Work Order ID 127674

Item Name: Floor Provisions

3.0 INSTALLATION CHANGES FOR D350-689-023

DESIGN		DART AEROSPACE LTD	
DRAWN		HAWKESBURY, ONTARIO, CANADA	
CHECKED		DRAWING NO.	REV. B
MFG. APPR.	N/A	DSI 9588	SHEET 2 OF 6
APPROVED		TITLE	SCALE
DE APPR.		INSTALLATION CHANGE	NTS
DATE	12.11.09	COPYRIGHT © 2011 BY DART AEROSPACE LTD THIS DOCUMENT IS PRIVATE AND CONFIDENTIAL AND IS SUPPLIED ON THE EXPRESS CONDITION THAT IT IS NOT TO BE USED FOR ANY PURPOSE OR COPIED OR COMMUNICATED TO ANY OTHER PERSON WITHOUT WRITTEN PERMISSION FROM DART AEROSPACE LTD.

FIGURE 1: UPDATES TO CROSS SECTIONS F-F AND M-M
 With reference to Figures 5 and 7 of IIN-D350-689
 (Figures 25-5 and 25-7 of ICA-D350-689)

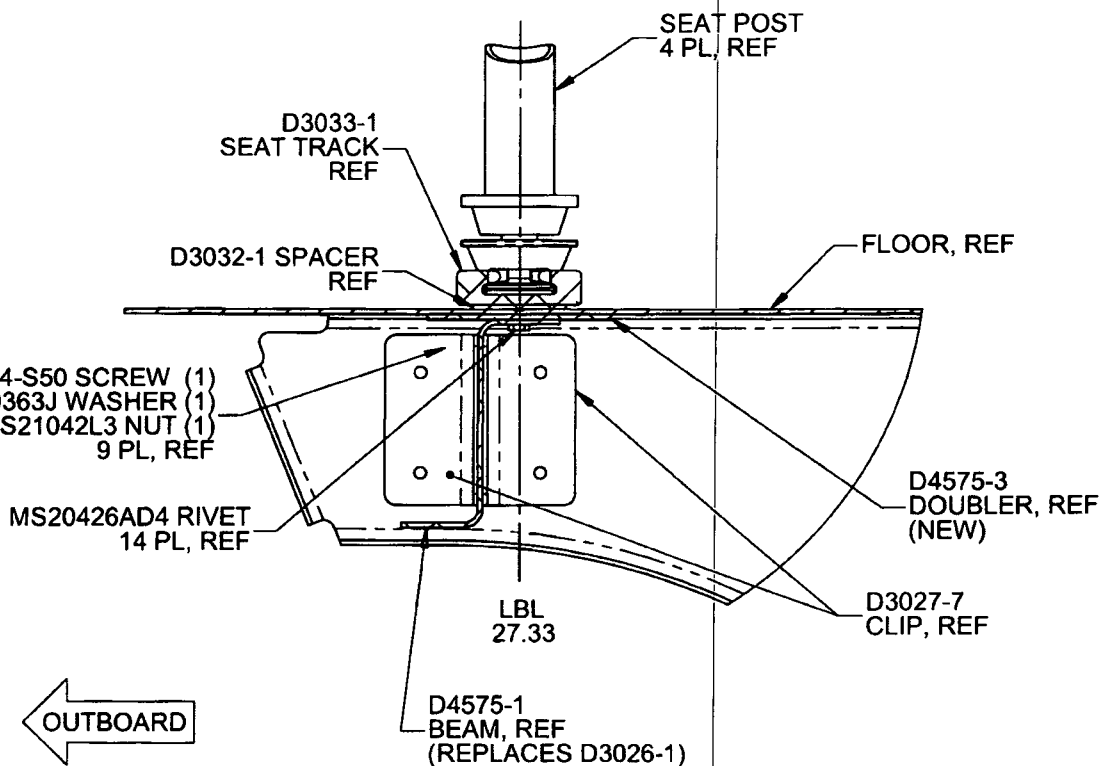
If there is an existing stringer at LBL 27.33, it will need to be removed from that location. Locate D4575-1 Beam and D4575-3 Doubler as shown in Figure 2 of this Service Instruction. Transfer drill existing holes from the aircraft floor to the D4575-1 Beam and D4575-3 Doubler. Ensure 1.0" to 1.5" rivet pitch and add additional holes if required. If there is no existing stringer, locate D4575-1 Beam and D4575-3 Doubler as shown in Figure 1 of this Service Instruction and drill Ø0.128" holes on a 1.0" to 1.5" pitch.

CROSS SECTION VIEW F-F/M-M: From Figures 5 and 7 (IIN-D350-689)
CROSS SECTION VIEW F-F/M-M: From Figures 25-5 and 25-7 (ICA-D350-689)

FIGURE 2: UPDATES TO FIGURE 21 (IIN-D350-689) AND 25-21 (ICA-D350-689)
 With reference to Figures 19 and 20 of IIN-D350-689
 (Figures 25-19 and 25-20 of ICA-D350-689)

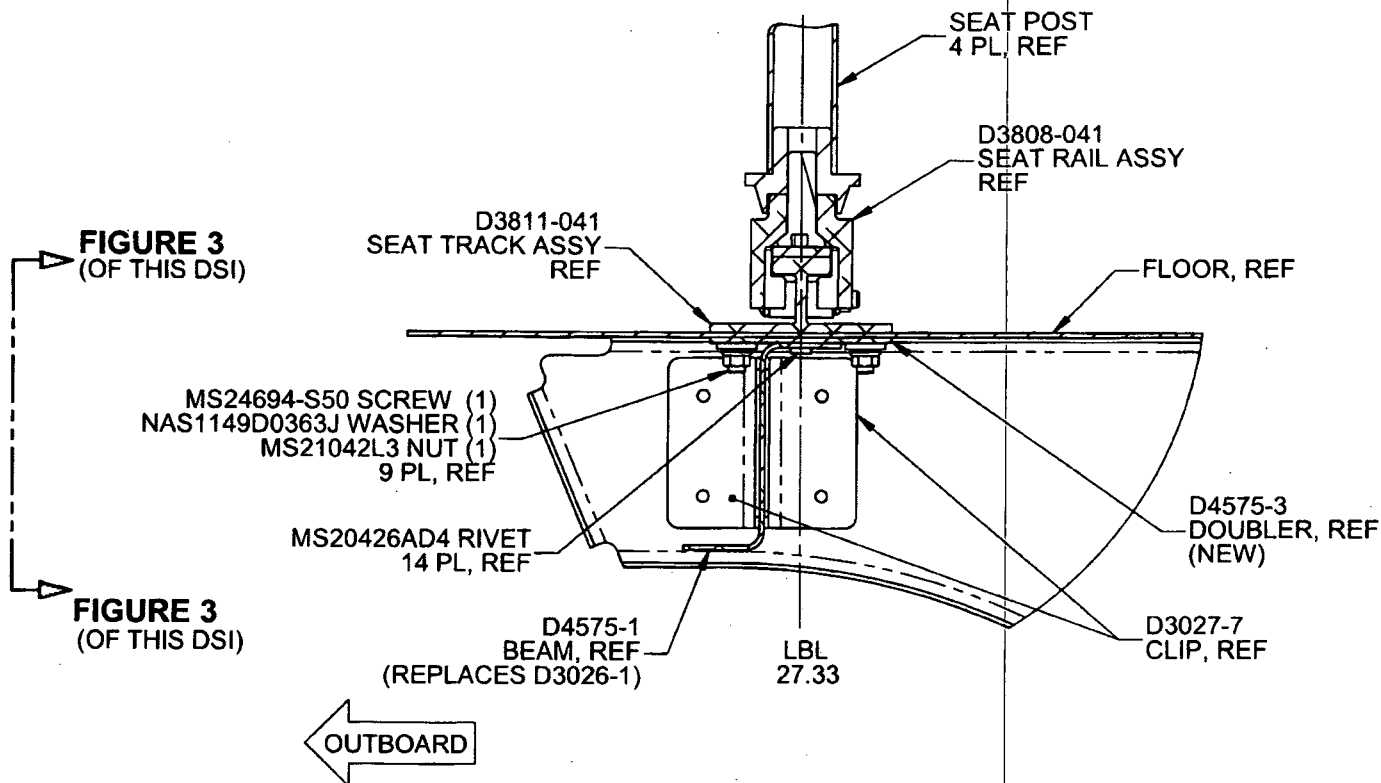
FIGURE 21: Cross Section View T-T from Figure 19 (IIN-D350-689)
FIGURE 25-21: Cross Section View T-T from Figure 25-19 (ICA-D350-689)

FIGURE 3: RELIEFS ON D4575-1/-3
(ONLY D4575-1/-3 SHOWN FOR CLARITY)
VIEW LOOKING INBOARD

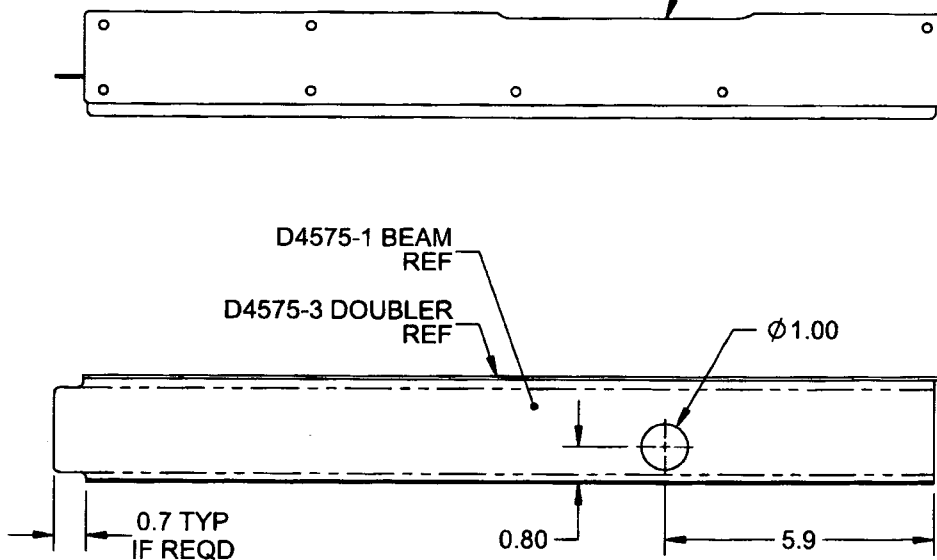
Note: Drill a Ø1.00" (Ø25.4 mm) hole in the D4575-1 Beam to clear extension tube of collective and cutout as required for clearance of collective opening and fwd bulkhead as shown in Figure 3 of this Service Instruction.

TRANSFER EXISTING CUTOUT
FROM AIRCRAFT FLOOR A/R TO
D4575-1/-3 FOR COLLECTIVE OPENING
